Botley West Solar Farm

Hydrology And Flood Risk Technical Note – Swinford HDD Crossings

EN010147/APP/17.10

This technical note has been prepared to support discussions with the Environment Agency (EA) regarding the temporary Swinford Horizontal Directional Drill (HDD) location and associated flood risk. The Swinford Crossing HDD locations refer to HDD 6 Option A and B. This note aims to provide further details of the flood risk at the proposed HDD crossing locations at Swinford (HDD 6, either option A or B), justification of their location and intended mitigation.

Figure 1. Environment Agency Flood Map for Planning

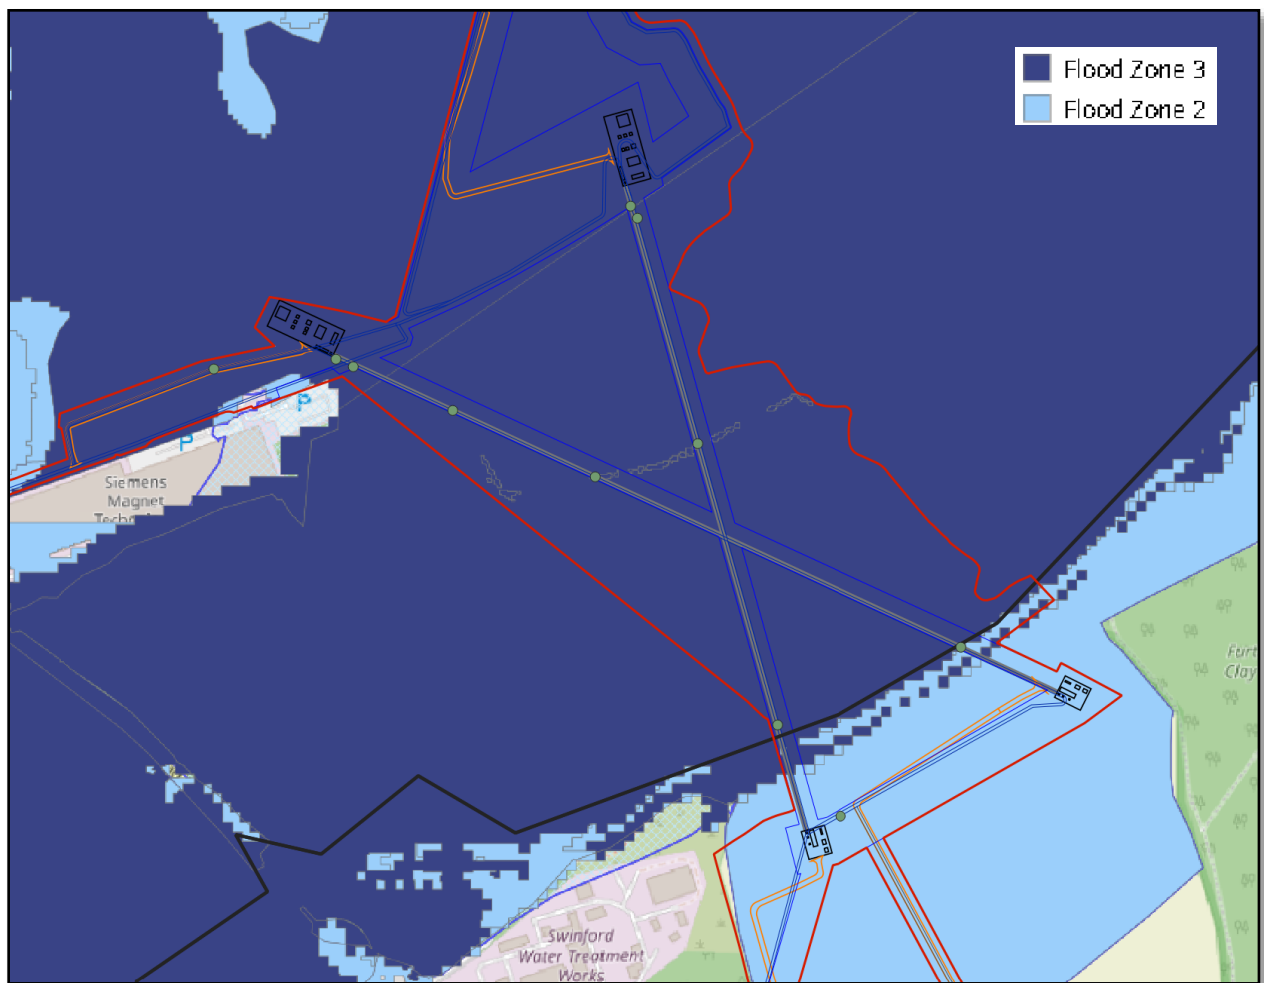
“Provide mapping that shows Flood Zones 3a and 3b with proposed components and the cable corridor route. Minimise interaction with Flood Zone 3b.”

“The preferred approach is to avoid locating Horizontal Directional Drilling (HDD) entrance and exit pits within Flood Zone 3b, due to its designation as functional floodplain and the associated flood risk. We note potential entry / exit pits within Flood Zone 3b on Sheet 10 of 13 and Sheet 11 of 13 of Figure 13.9

The EA Flood Map for Planning is presented within **Figure 1** and demonstrates that the Swinford Crossing HDD entry compounds (HDD 6, Option A and B) are located within Flood Zone 3, and the HDD exit pit compounds are located within Flood Zone 2.

Figure 2. West Oxon SFRA Mapping

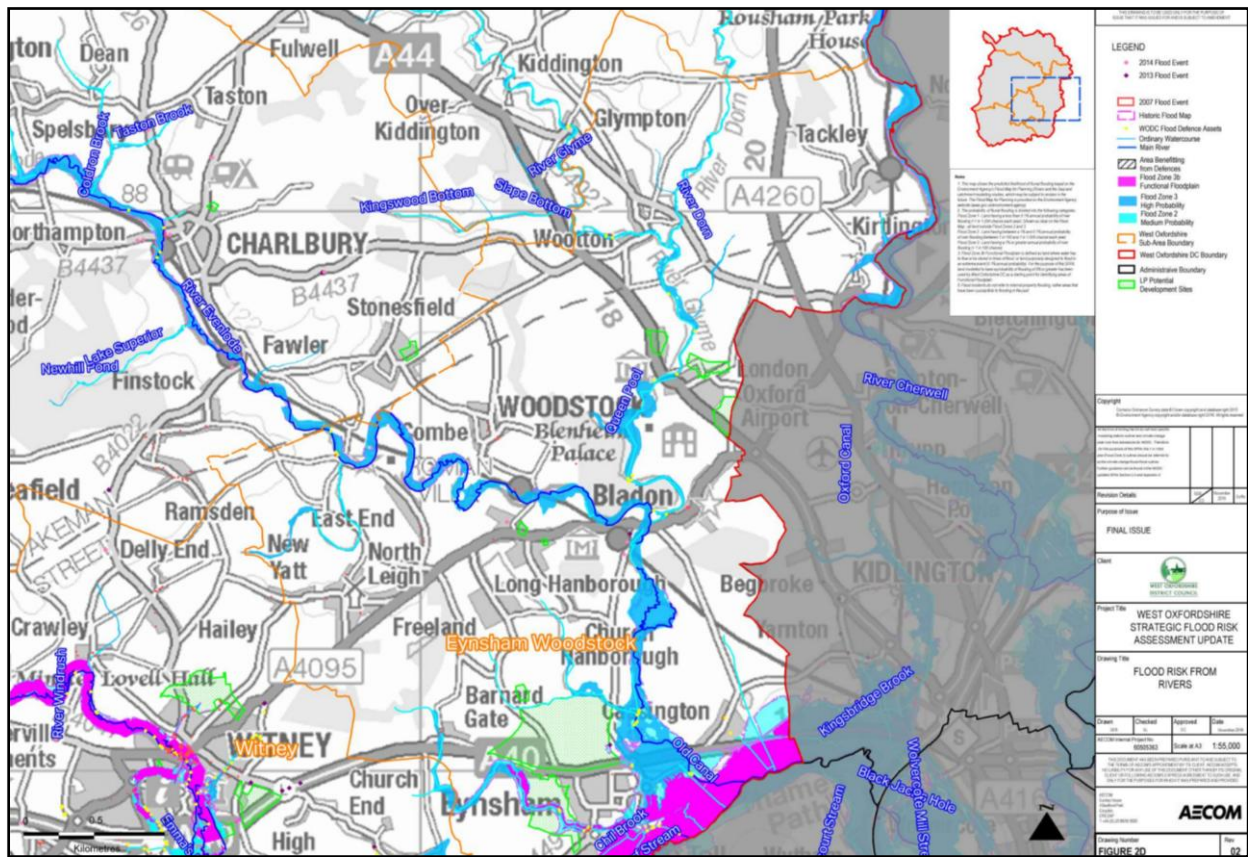
A notable concern relates to the proposed HDD entrance pits near Swinford, on the north bank of the River Thames, which appear to potentially fall within Flood Zone 3b and an area that experienced significant flooding during the winter of 2013–2014.

An extract from the Flood Risk from Rivers mapping within the West Oxon Strategic Flood Risk Assessment is presented below in **Figure 2**. This shows the entrance pits of the Swinford Crossing HDD are located within Flood Zone 3b, land with a greater than or equal to 3.3% chance of flooding in any given year (1 in 30-year return period). It is noted that the figure was created in 2016.

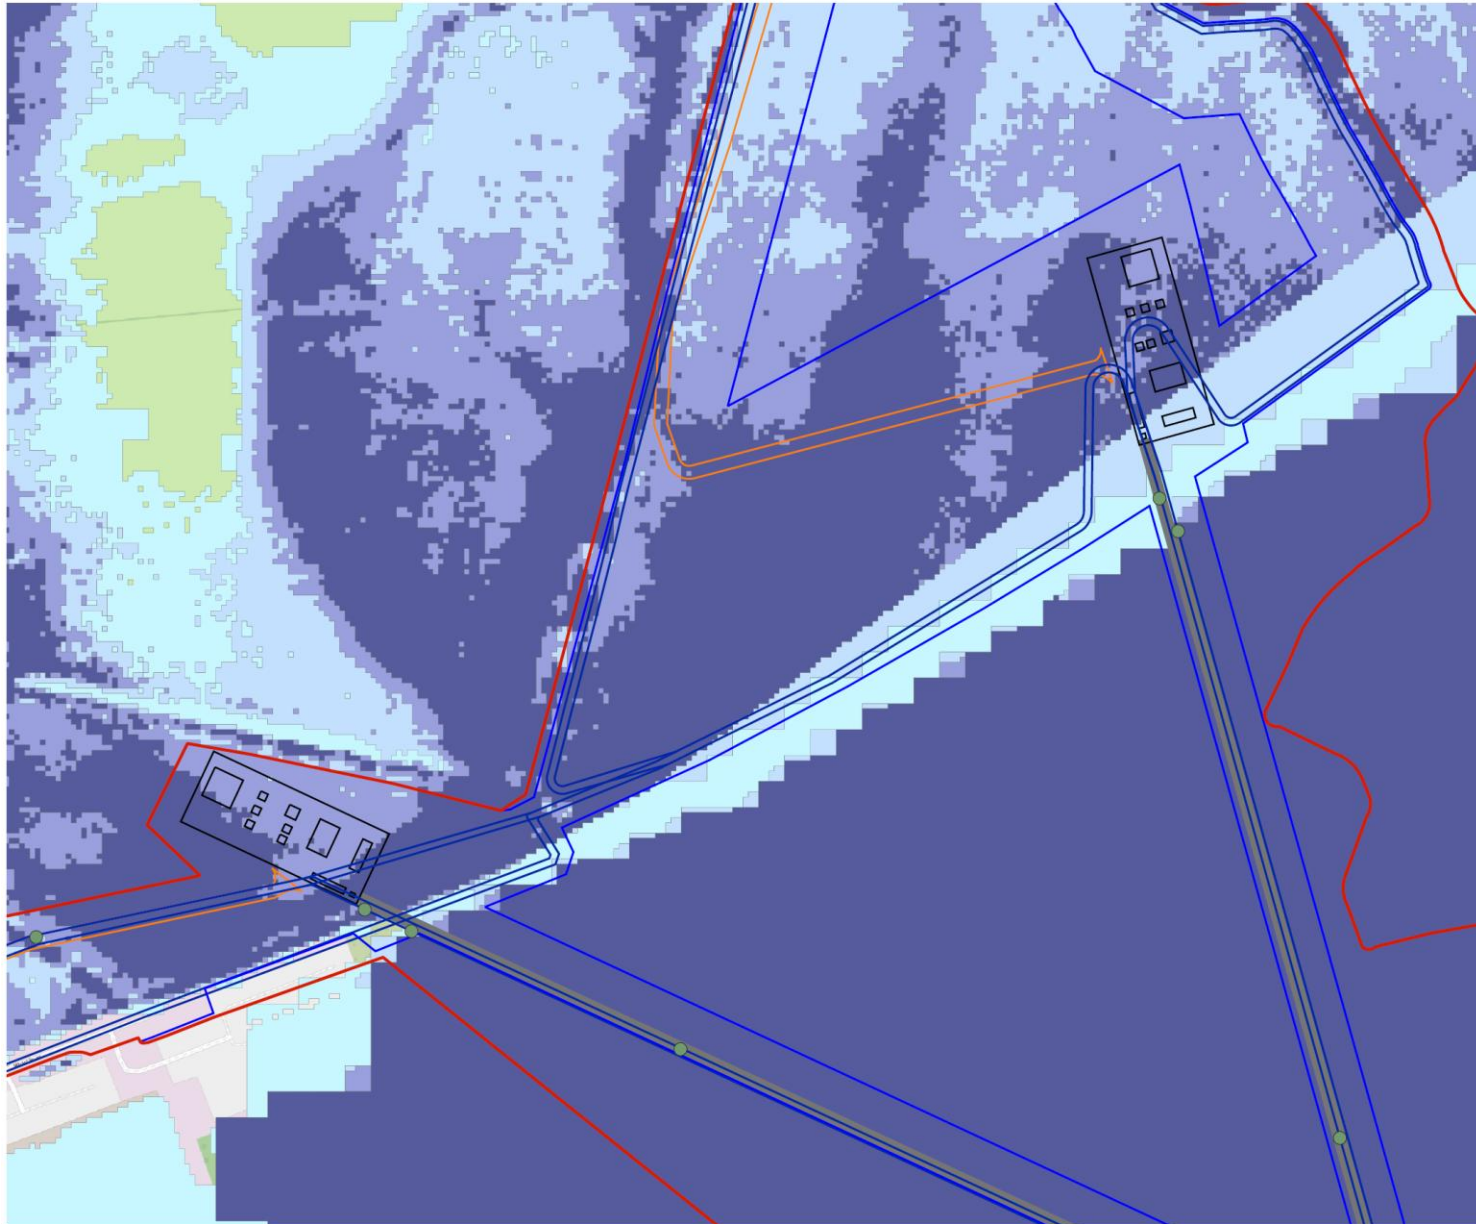
Given the location of the entrance pits within a high-risk flood area, there is also potential for flood flow routes through the HDD tunnel to the opposite bank of the Thames. The applicant should assess this risk and clearly outline the mitigation measures.

As flood depths impacting both HDD entry pits are assessed up to 0.6m, additional flood resistance measures are proposed to reduce the risk of flooding to the HDD entry pit compounds during the construction phase. There is a potential risk of flood flow routes through the HDD tunnel to the opposite bank of the Thames.

- Installing temporary flood barriers or cofferdams during construction to protect points of entry/exit points from water inundation.
- Implementing robust tunnel lining and sealing techniques to ensure structural integrity and prevent leakage.
- Monitoring groundwater and flood levels continuously during construction.
- Developing an emergency response plan to address any unintended flood flow through the tunnel.
